CENTRAL VALLEY FLOOD MANAGEMENT PLANNING PROGRAM

Errata to the Public Draft

2012 Central Valley Flood Protection Plan

Volume III – Attachments 8 through 8E

2. **Attachment 8 – Technical Analysis Summary Report, Figure 3-1, page 3-2**

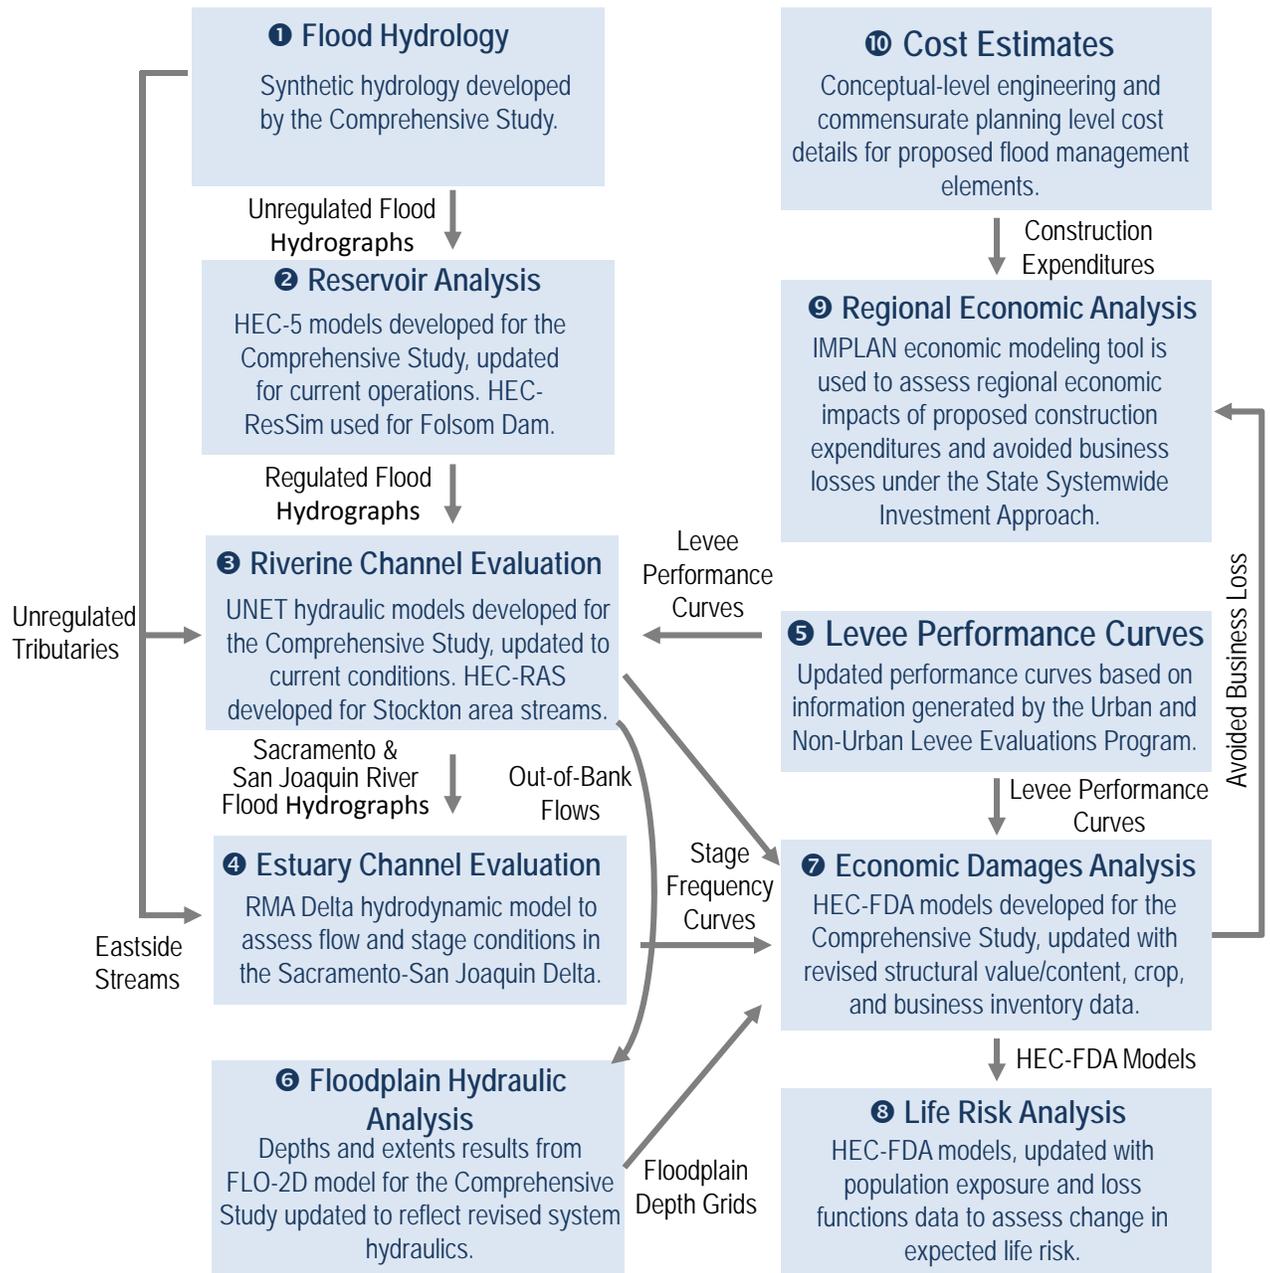
Replace Figure 3-1 “Technical Analyses and Tools Supporting 2012 CVFPP Development” with the following for color consistency.

13. Attachment 8E – Levee Performance Curves, Section 3.3, page 3-6, Figure 3-1

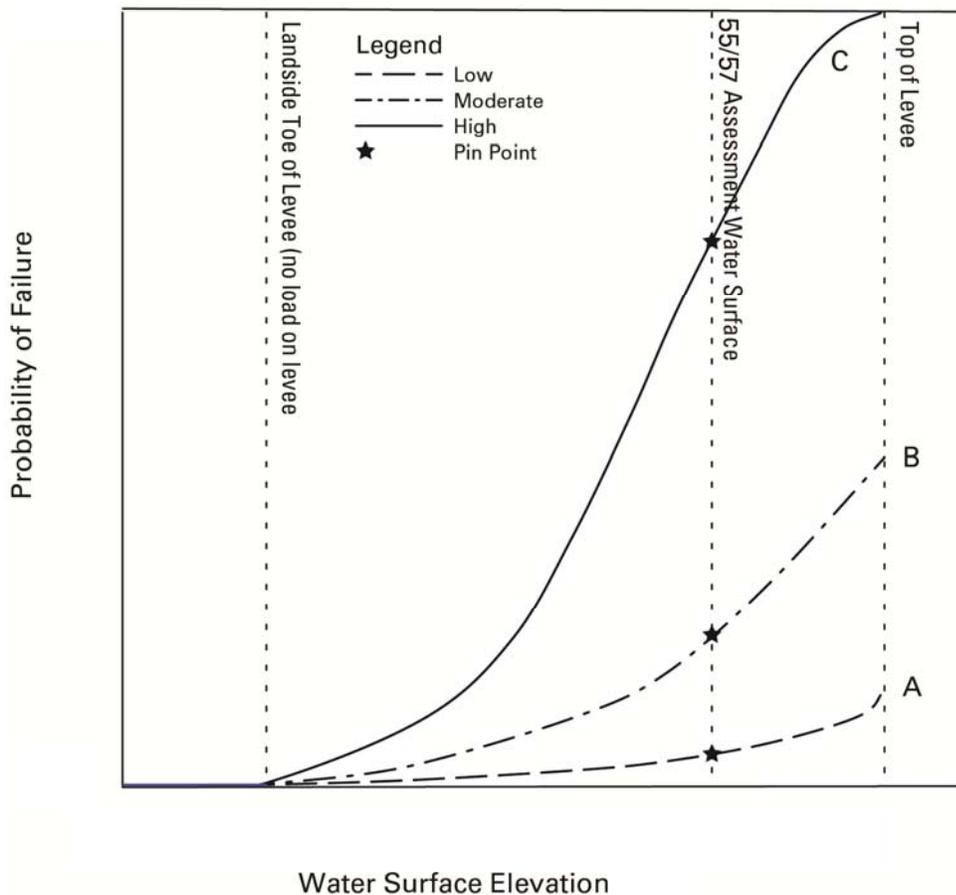
Replace Figure 3-1 “Conceptual NULE Levee Performance Curves for Hazard Categories Low (A), Moderate (B), and High (C)” with the following:

Note: Values in figure are not to scale

14. Attachment 8E – Levee Performance Curves, Section 3.3, page 3-8, Figure 3-2

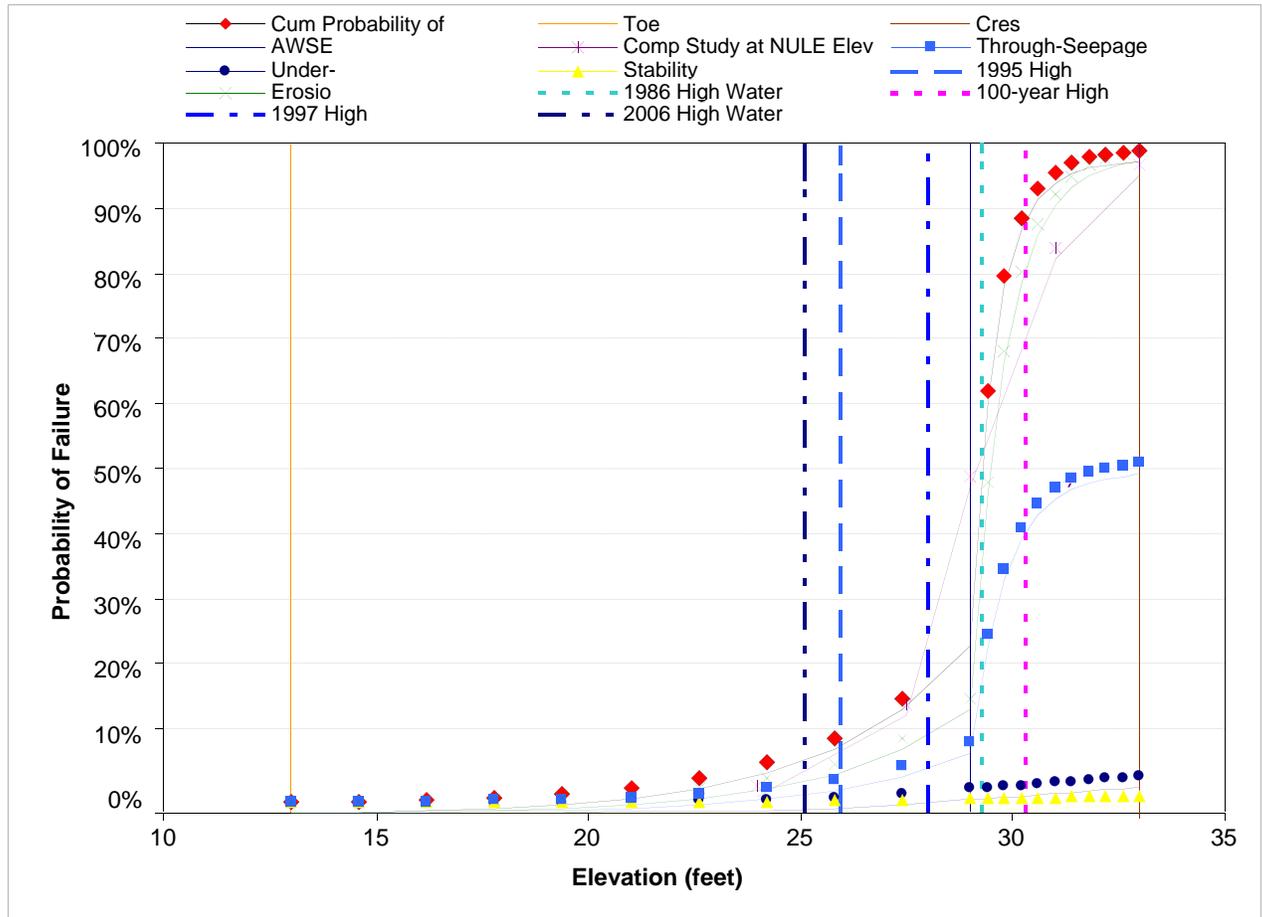
Replace Figure 3-2 “Example NULE Levee Performance Curve” with the following:

Note: These curves represent a levee segment with the following hazard categories from the GAR: Moderate (B) for underseepage, Low (A) for stability, LD (Moderate (B) or High (C)) for through-seepage, and High (C) for erosion.
